APPENDIX O2

Design Deviations

I-405, SR520 to SR522 Stage 1 (Kirkland Stage 1)

Draft RFP

Limited Access Design Deviation
Exhibit 10
Total Accident Analysis in Project Area
Jan 01 to Dec 03

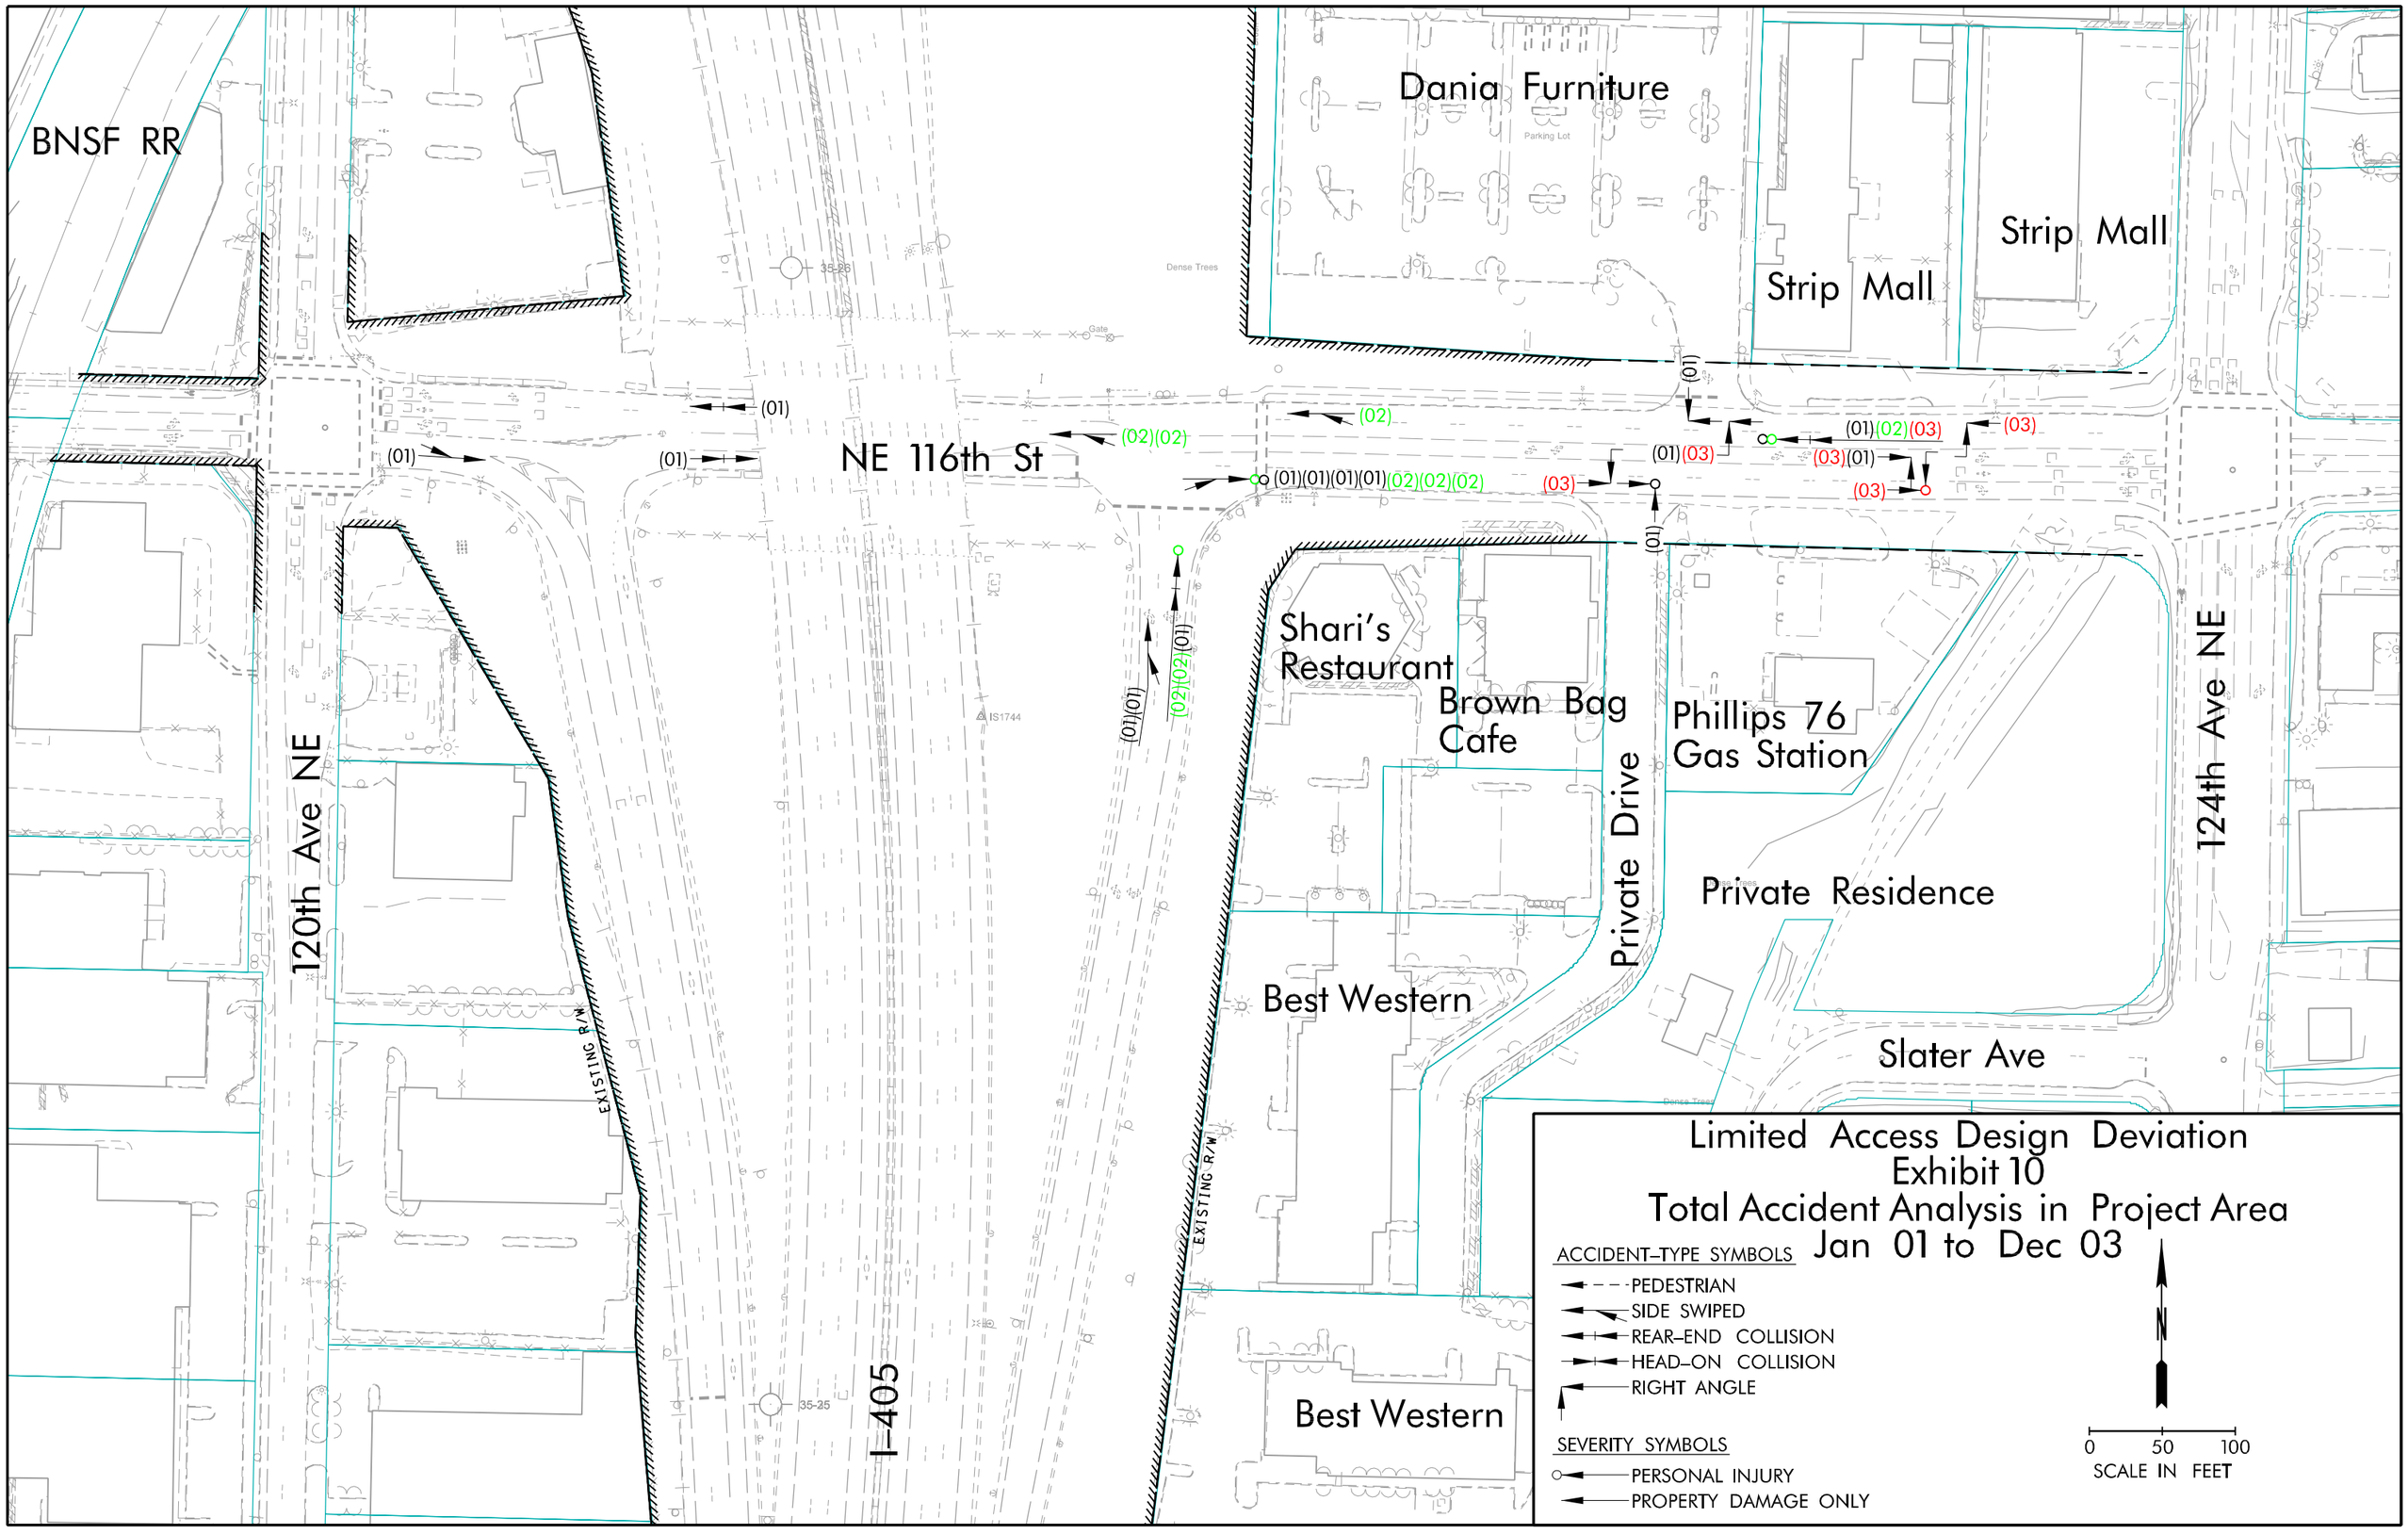
- Exhibit 10 shows all the accidents within the project limits on NE 116th St between 120th Ave NE and 124th Ave NE. These include an additional seven accidents associated with the driveways east of I-405 for a total of twelve accidents altogether. Three accidents, including two with injuries, were rear-ends occurring in a queue on NE 116th St. One accident was a vehicle turning left from the strip mall driveway. Three accidents, including one injury, were associated with the Conoco Phillips 76 gas station and vehicles making left turns.
